Access Compliance Report

Public Rights-of-Way

Intersection ID: 47280	Main Street: SAVANNAH_HILLS_DR	Cross Street: LAMPLIGHTER_CLOSE_DR	Location: NE
ADA ID: 46DB2AB3EF2D	Ramp Type: PerpDiag	Initial Pass/Fail: Fail	Overall Compliance: No
		Severity Score: 10

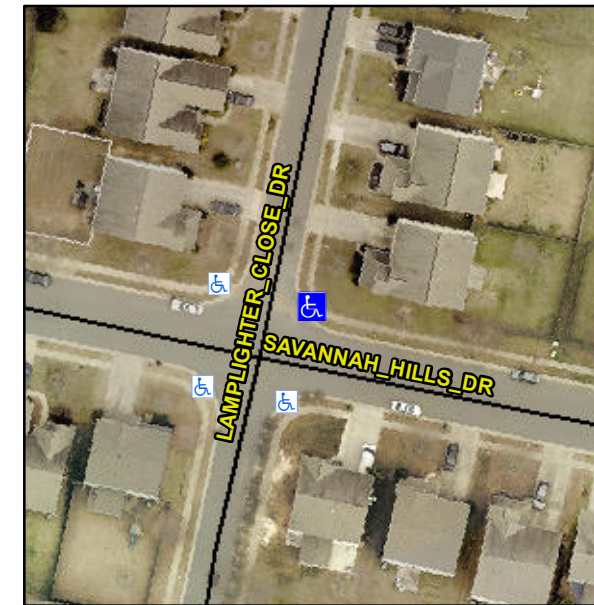
Not Found, R304.5.1, R304.5.3

Compliance	Description	Data	Compliance	Description	Data
N/A	Ramp Length (in)	48.0	Yes	Ramp Slope (%)	7.9
No	Ramp Width (in)	46.0	No	Ramp XSlope (%)	2.5
N/A	Flare Type LT	N/A	N/A	Flare Type RT	N/A
N/A	Flare Slope LT (%)	N/A	N/A	Flare Slope RT (%)	N/A
N/A	Flare Traversable LT?	N/A	N/A	Flare Traversable RT?	N/A
N/A	Landing Length (in)	N/A	N/A	DWS Provided?	N/A
N/A	Landing Width (in)	N/A	N/A	DWS Contrast?	N/A
N/A	Landing Slope (%)	N/A	N/A	DWS Length (in)	N/A
N/A	Landing X Slope (%)	N/A	N/A	DWS Full Width?	N/A
N/A	Landing Curb? (Y/N)	N/A	N/A	DWS Offset (in)	N/A
N/A	Shared Landing?	N/A			
N/A	Gutter Ponding?	N/A	N/A	Gutter Slope (%)	N/A
N/A	Gutter Lip Ht (in)	N/A	N/A	Gutter X Slope (%)	N/A
N/A	Painted X Walk1?	No	N/A	Painted X Walk2?	No
	X Walk 1 Direction	To W		X Walk 2 Direction	To S
N/A	X Walk 1 Width (in)	N/A	N/A	X Walk 2 Width (in)	N/A
	X Walk 1 Slope (%)	0.7		X Walk 2 Slope (%)	4.7
	X Walk 1 X Slope (%)	0.4		X Walk 2 X Slope (%)	2.3

Remove & Replace Curb Ramp With Two New Directional Ramps or Equivalent.
